MEMORANDUM THRU: CO-M
CO

SUBJECT: Potential alternatives for Galveston Beach Fill Job to Decrease Costs.

PROPOSED BEACH
REPLENISHMENT PROJECT
101h STREET TO 103rd STREET
CITY AND COUNTY OF GALVESTON
STATE OF TEXAS
APPLICANT: CITY OF GALVESTON

SHEET 8 OF 15

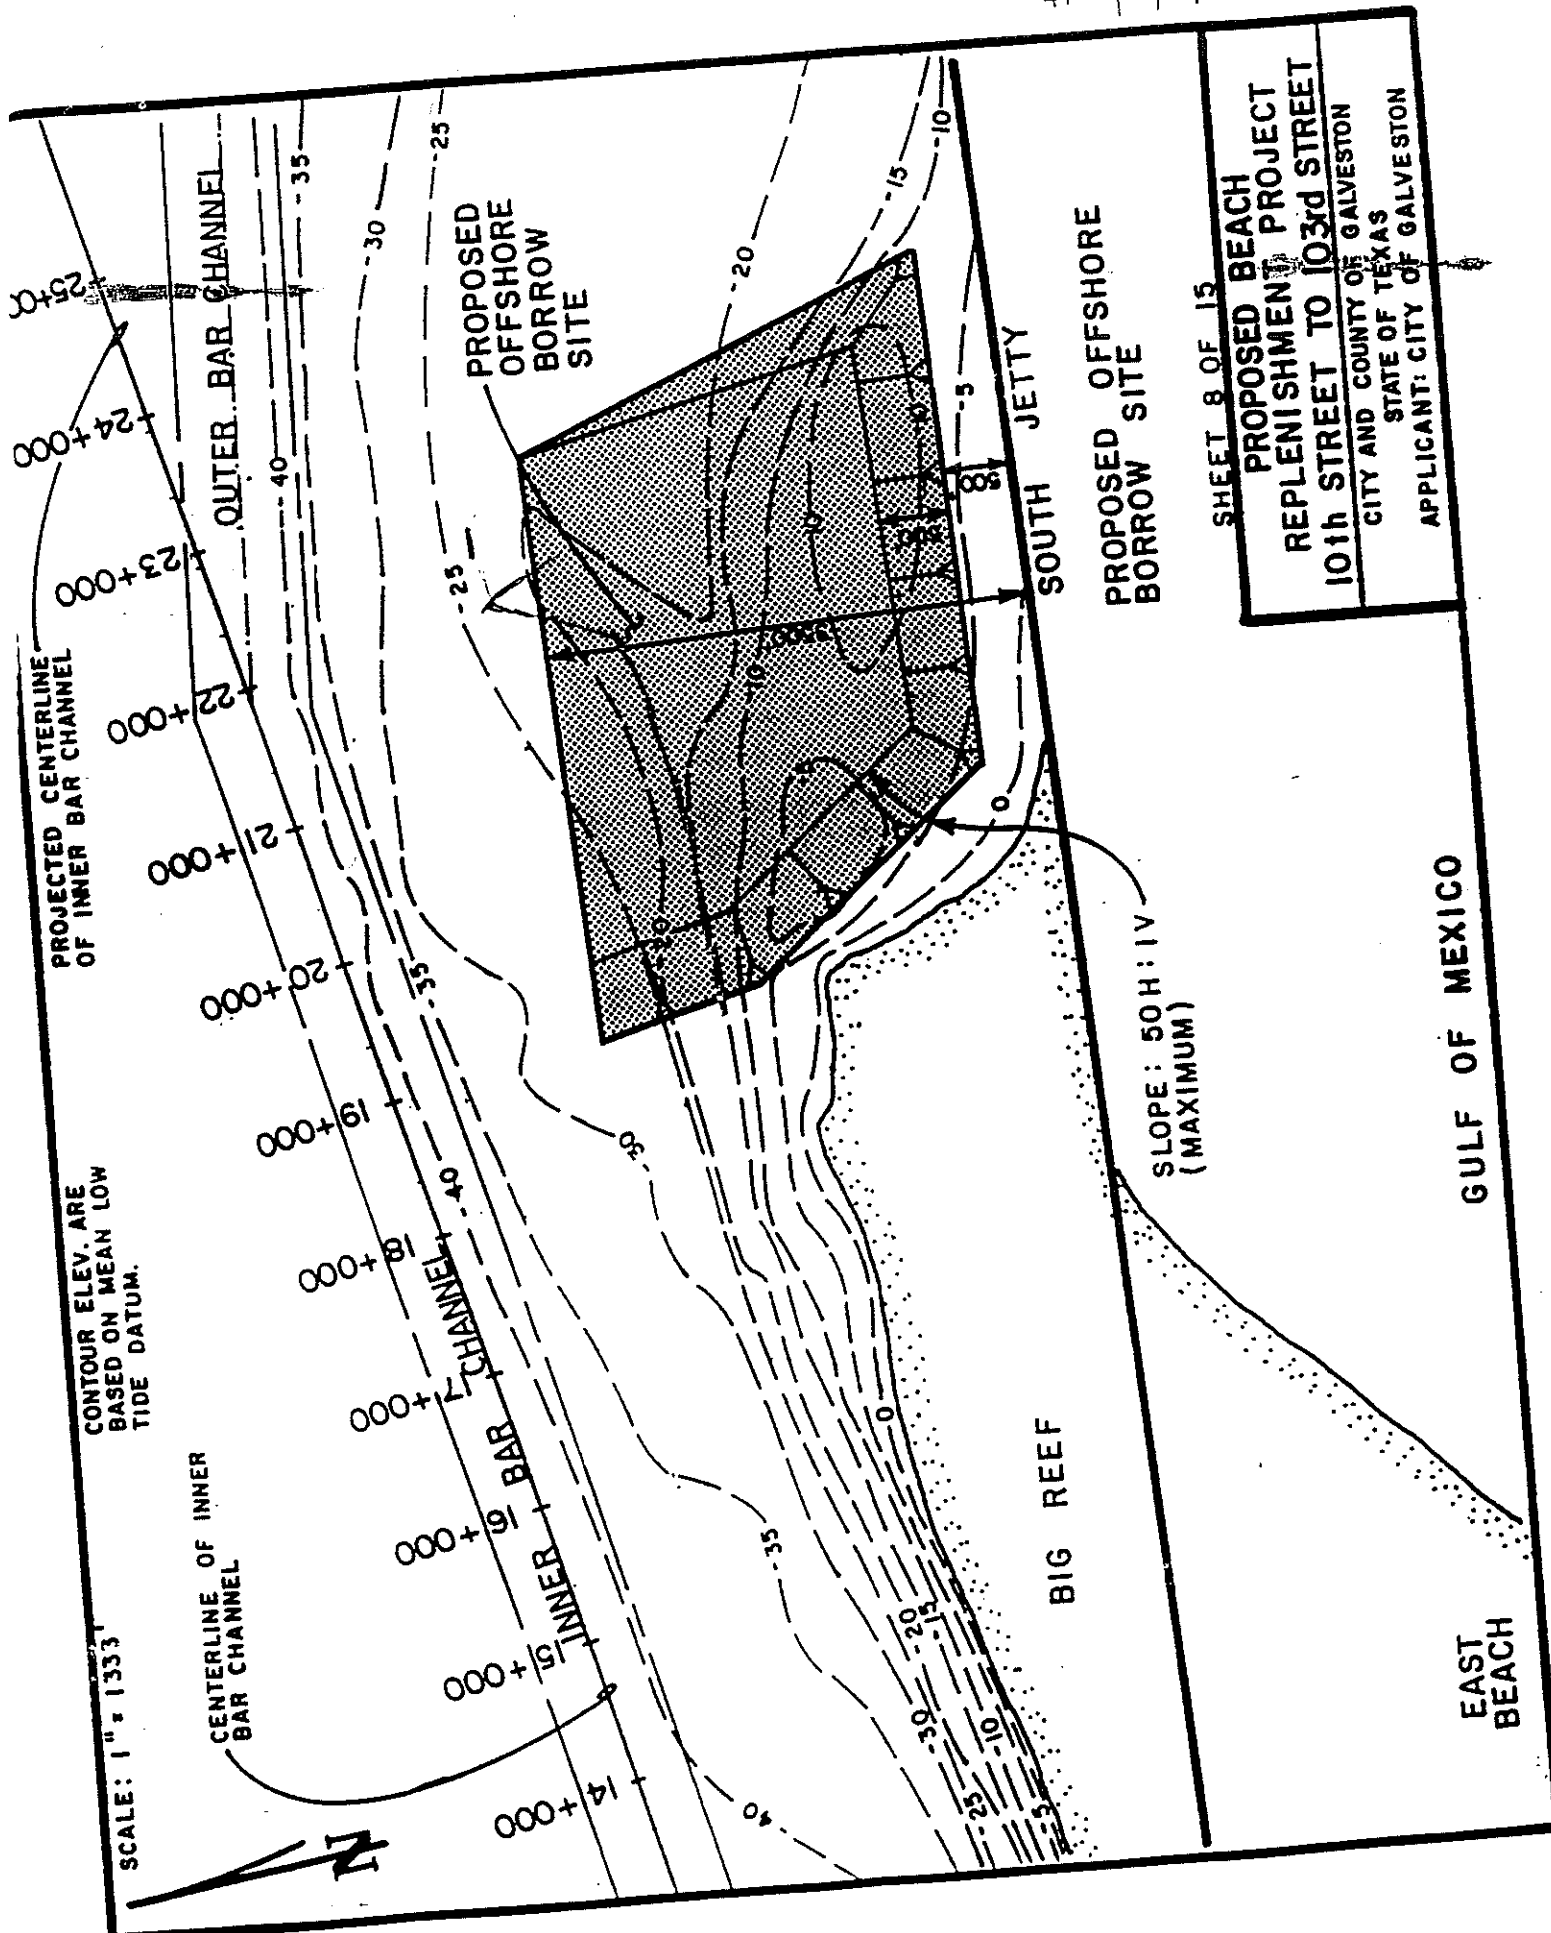
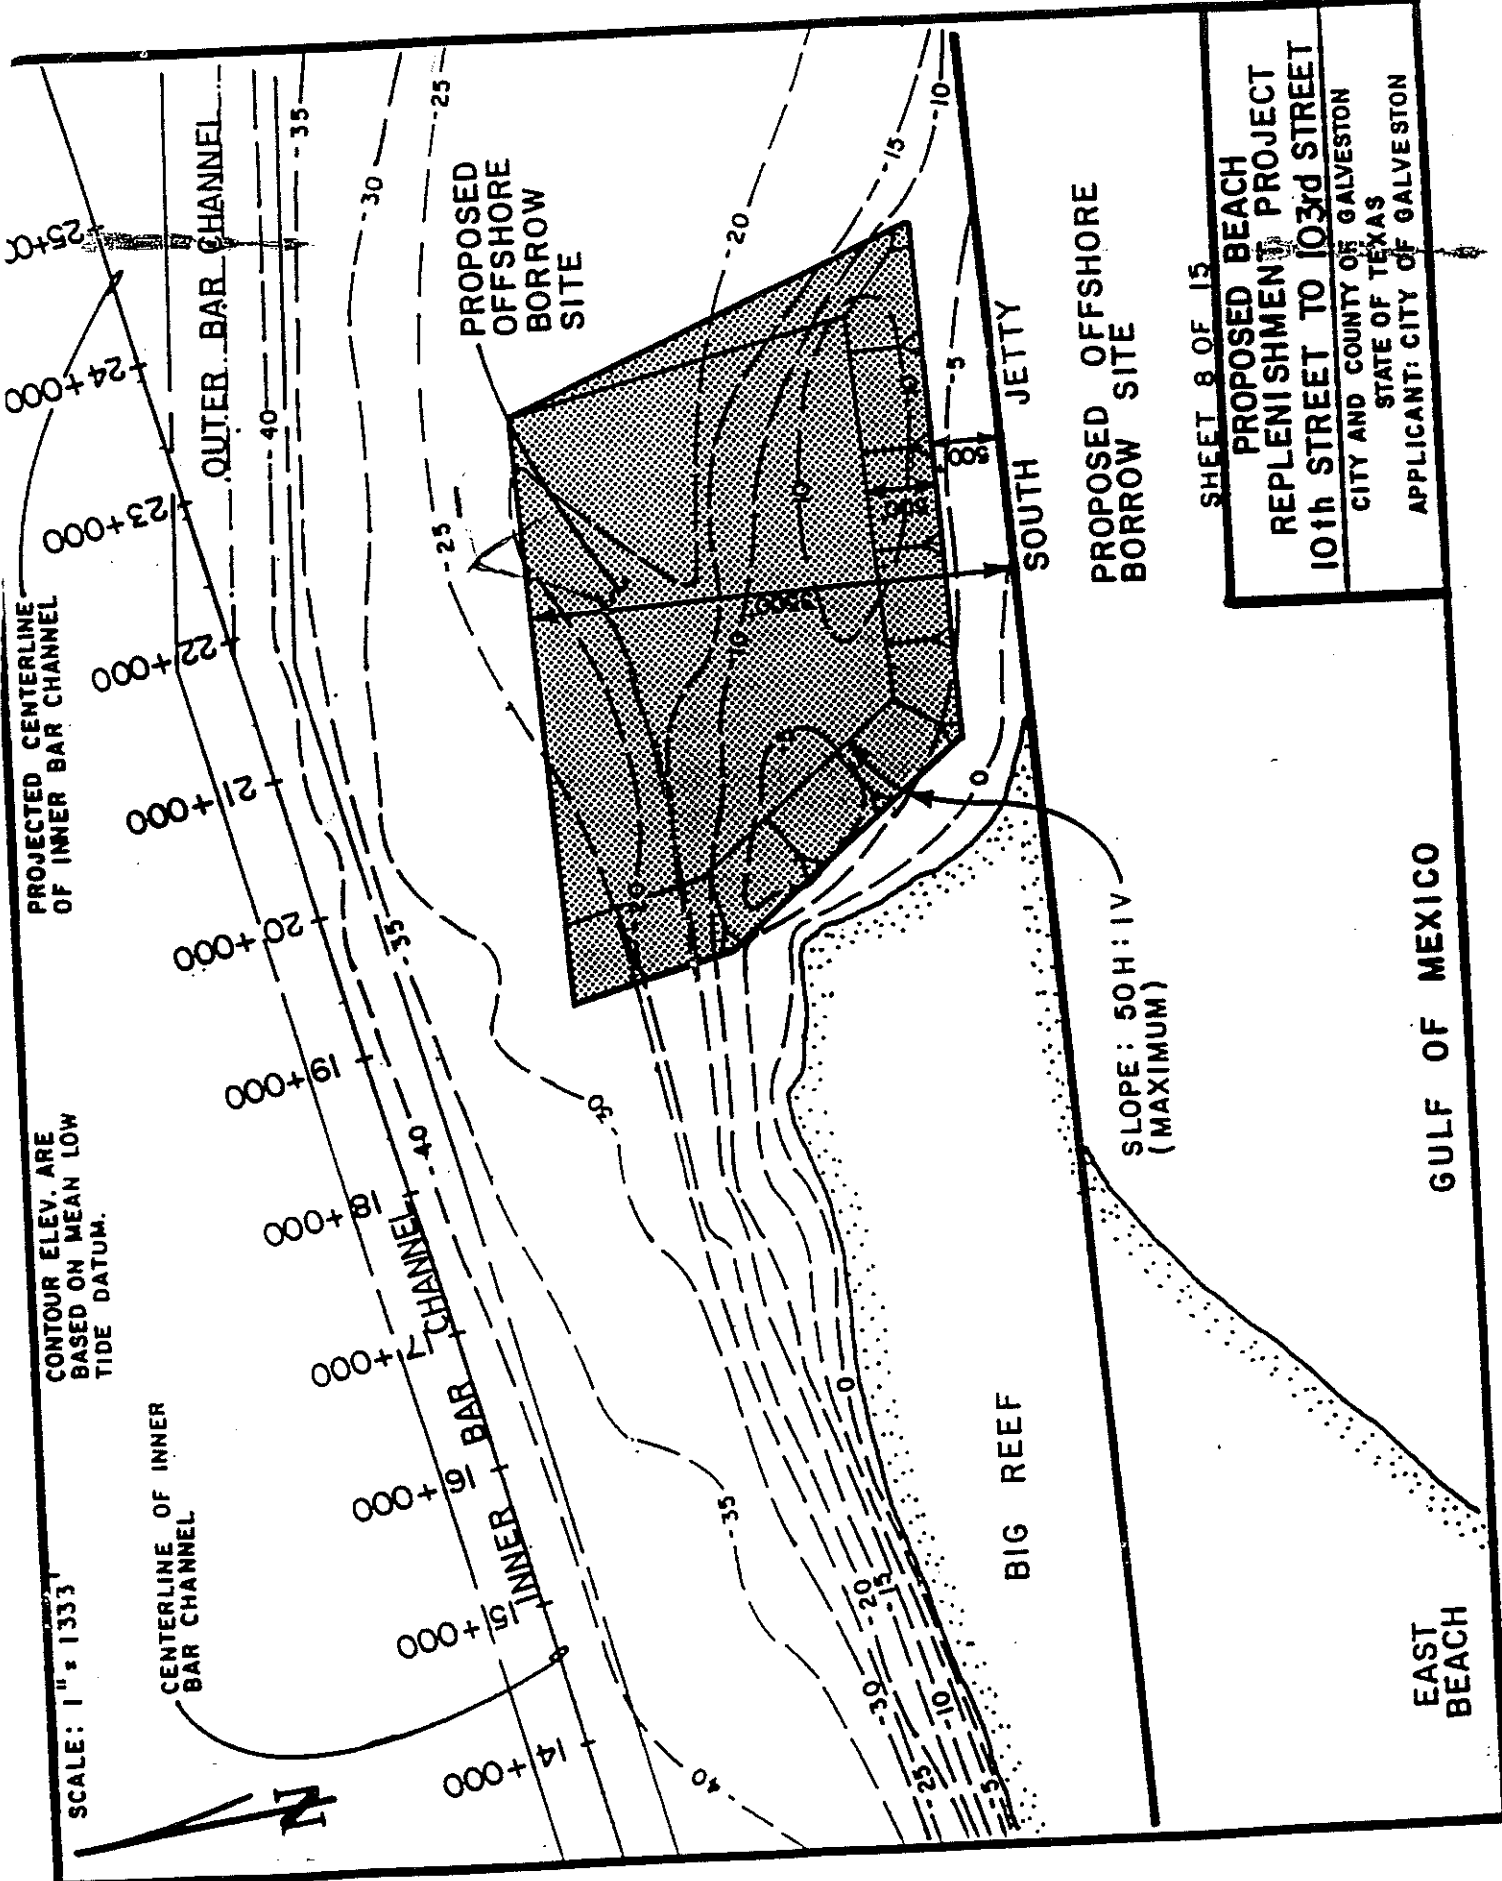
1. Recently the City of Galveston requested bids for construction a beach between 10th and 61st streets. The borrow area was located east of the landward portion of big reef and north of the south jetty (Figure 1). Bid prices were well above the estimated cost to complete the job. Contractors complaints on the job mainly centered on depth of cut available to complete the job, pipeline length, contractor liability and weather conditions. To reduce the cost of constructing a beach at Galveston some alteration will need to be conducted of the bid package.

2. Depth of Cut. Currently the depth of cut is limited by the proven availability of sand. The estimated average depth of cut for the project is approximately 4ft, reviewing the permit request. A large dredge, which would be required to complete this job, would more efficiently have a depth of cut between 8 to 12 ft. To increase the depth of cut an increased depth of sand would need to be proven at the site. Sediment cores collected prior to request for bids were limited by a stiff layer of material which could not be penetrated by the core. Additional cores may prove that additional sand is available below the stiff layer. Four to ten cores should verify what is below the stiff layer.

3. Pipeline length. Pipeline length can only be reduced by identifying a sand source closer to the fill location or a more direct route to the fill location. If an increased depth of cut can be determined feasible, then that portion of the borrow area closest to the beach can be used more, decreasing pumping distances. The only known borrow source available outside of the emergent portion of big reef would be the shoal west of big reef. NOAA charts, Figure 2, indicate that the shoal is located just west of the emergent section of big reef. Borrow from this area is less likely to cause problems with the emergent section of big reef and therefor a deeper borrow may be allowed. Pipeline lengths could be reduced by utilizing this borrow source and using an easement along the seawall to place the pipe. However,
